TECHNICAL EVALUATION REPORT

RADIOLOGICAL EFFLUENT TECHNICAL SPECIFICATION IMPLEMENTATION (A-2)

NORTH ANNA POWER STATION UNITS 1 AND 2

FRC PROJECT C5506

Figure 1. Liquid Radwaste Treatment Systems, Effluent Paths, and Controls for North Anna Power Station Units 1 and 2

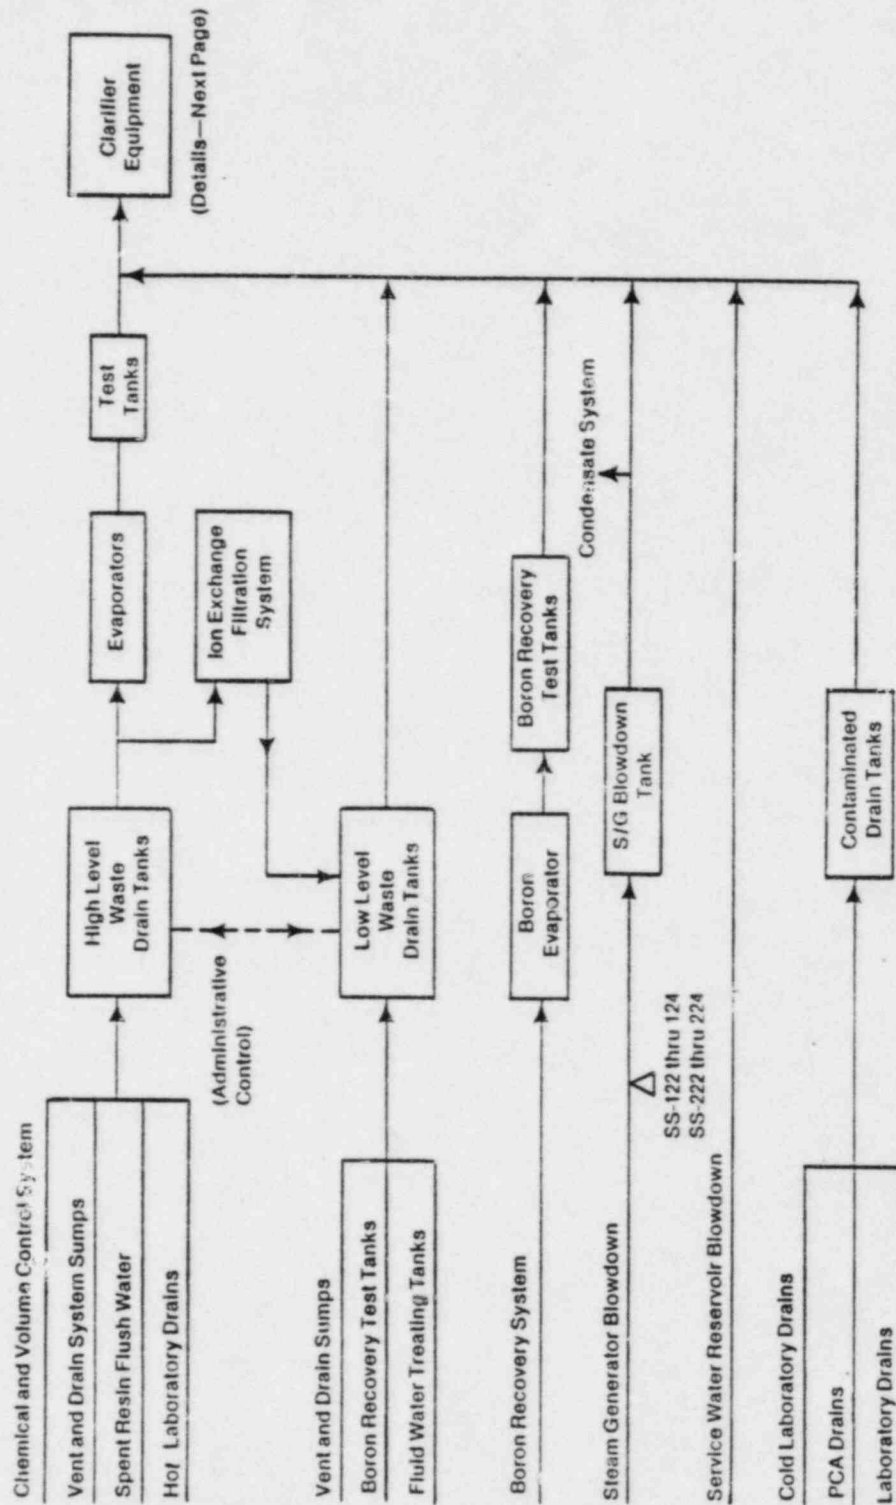
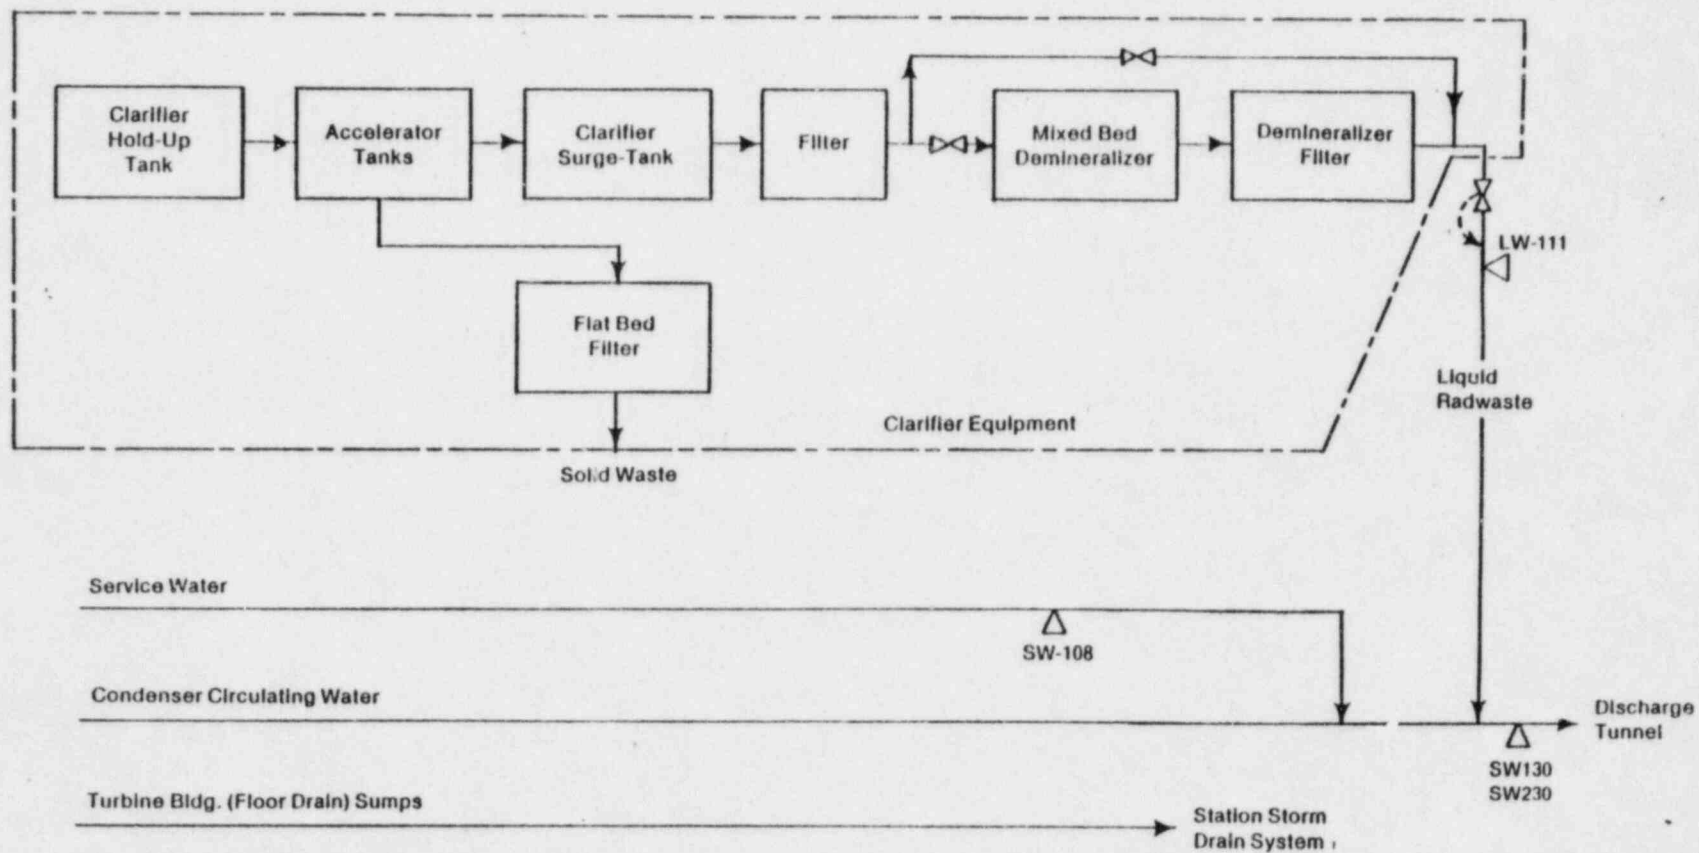
The liquid waste treatment system for the North Anna plant is common to both Units 1 and 2 (Figure 1). The liquid waste is primarily collected in high- and low-level waste drain tanks. This includes chemical and volume control, vent and drain sumps, spent resin flush, and hot laboratory drains for high-level waste; and vent and drain sumps, boron recovery test tanks, and fluid water treatment for low-level waste. All liquid waste is dumped into clarifier equipment which separates, through flat bed filters, the solid waste. The liquid radwaste effluent is then passed through demineralizers and then to the discharge tunnel. The liquid radwaste effluent line is monitored by LW-111, which provides alarm and automatic termination capability. The service water effluent line is monitored by SW-108. These two effluents lines, together with the condenser circulating water, lead to the circulating water discharge tunnel where monitors (SW-130, SW-230) are installed to monitor the liquid effluents before discharging into Lake Anna. The turbine building (floor drain) sump effluents are released directly to the station storm drain system; however, the Licensee does not provide on-line monitoring for this effluent line.

Although the Licensee does not monitor the turbine building liquid effluents, a commitment has been made to sample and analyze the turbine building sump if the activity of the secondary coolant exceeds 1×10^{-5} $\mu\text{Ci/ml}$. The Licensee has established an ongoing sampling and analysis program for the batch release tanks as well as for continuous releases, as described in the Licensee's final submittal.

Figure 2. Gaseous Radwaste Treatment Systems, Effluents Paths, and Controls for North Anna Power Station Units 1 and 2

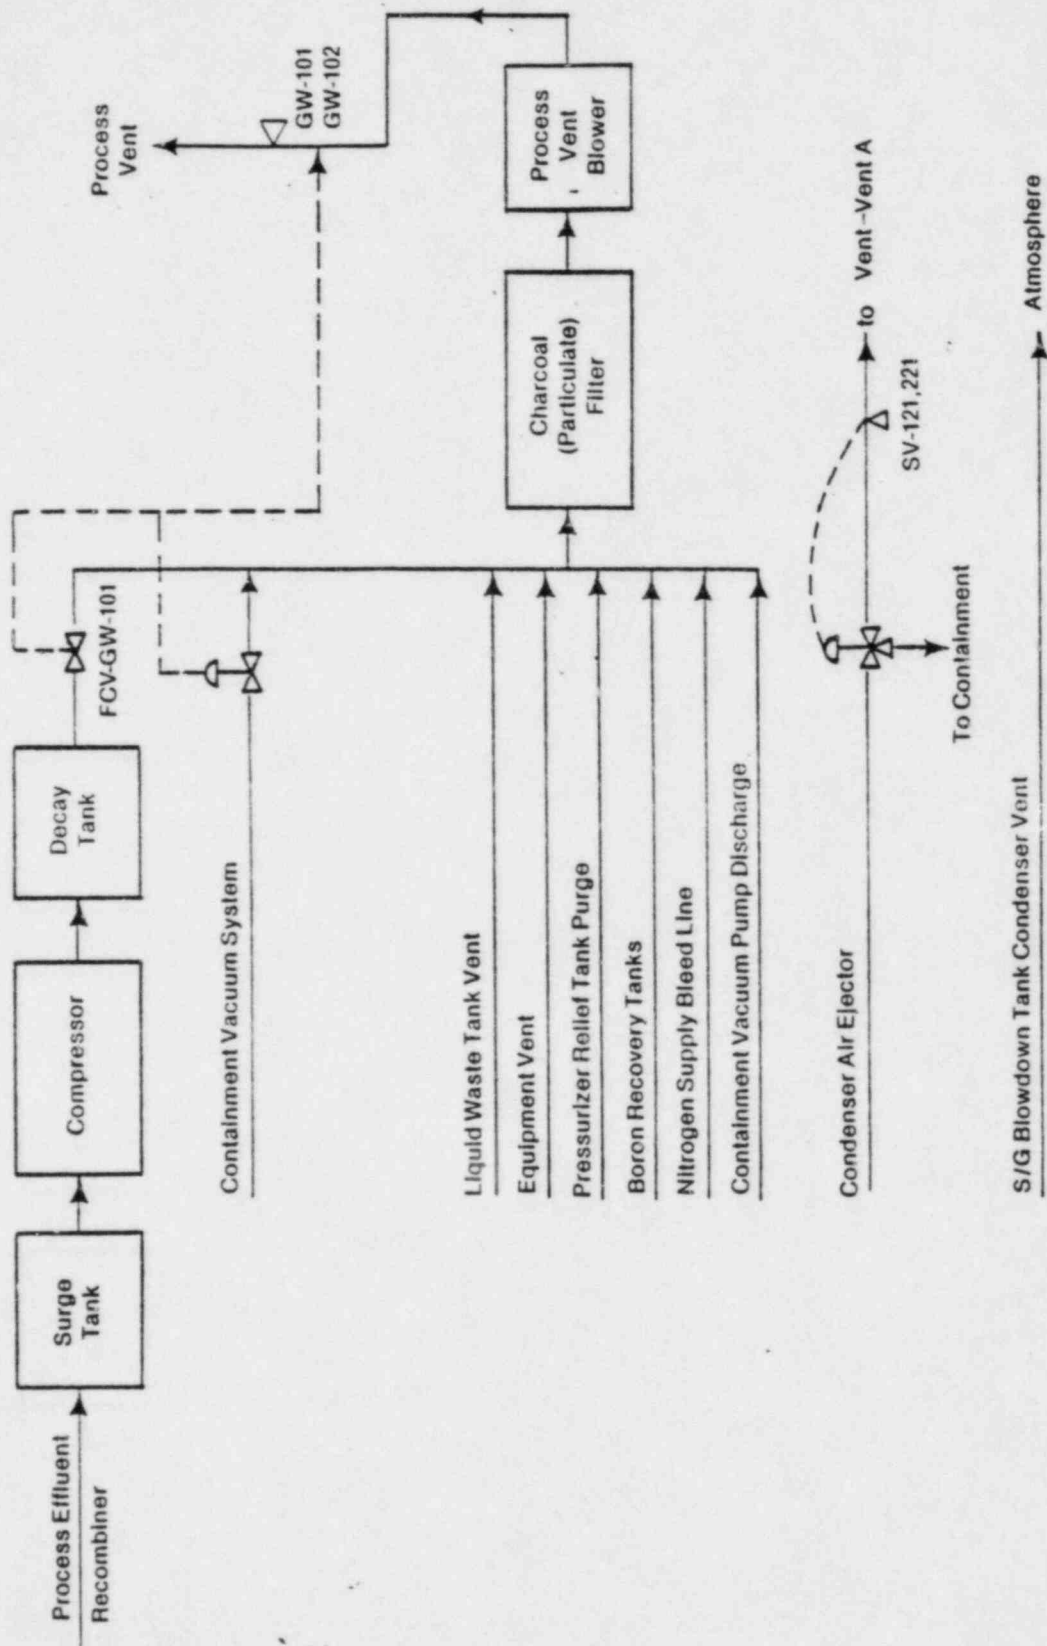
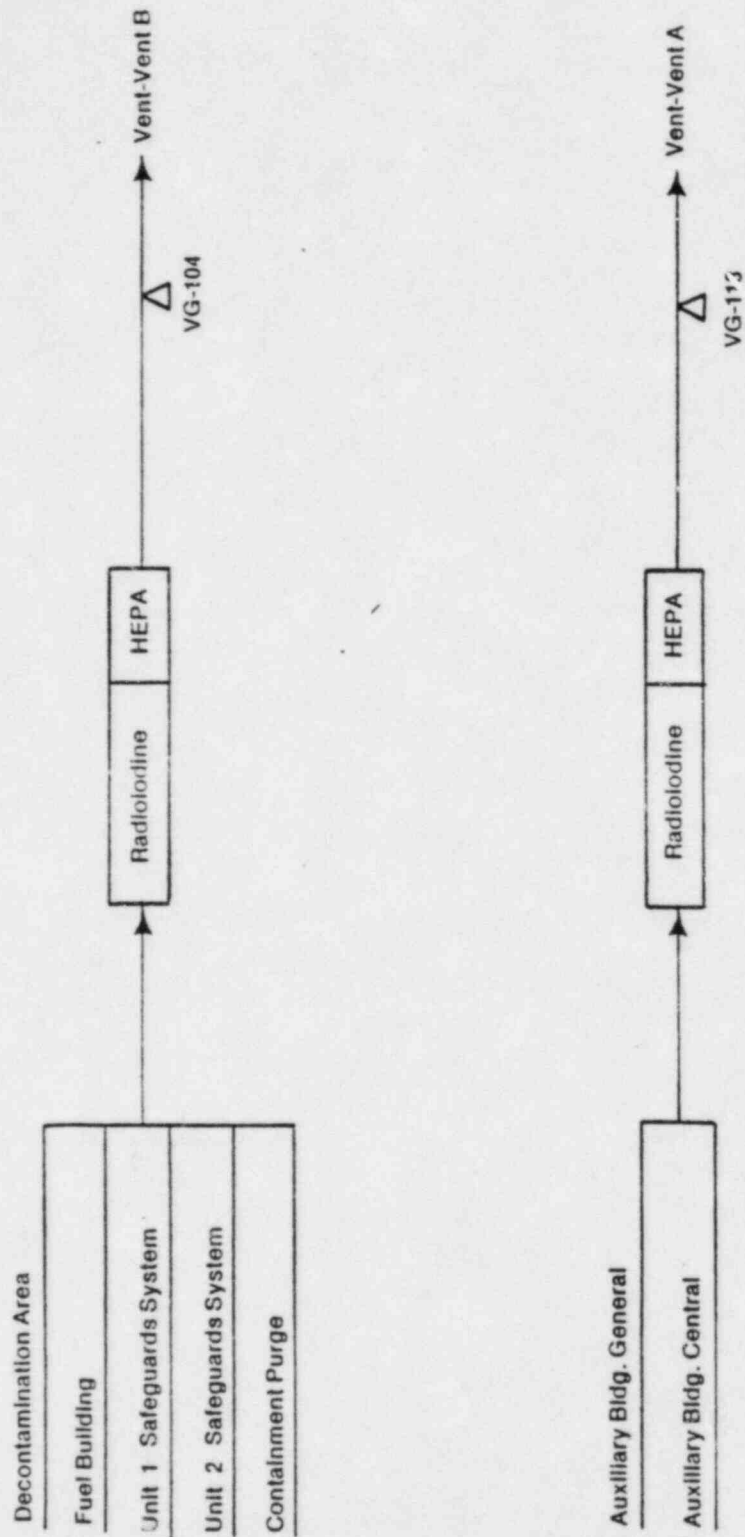
The gaseous waste treatment system for the North Anna plant is also common to both Units 1 and 2 (Figure 2).

The process effluent from the recombiner is stored in the decay tank, where the effluents are released together with other streams into the process vent where releases are considered as mixed mode. The process vent has monitors GW-101 and GW-102 which have capabilities to automatically isolate
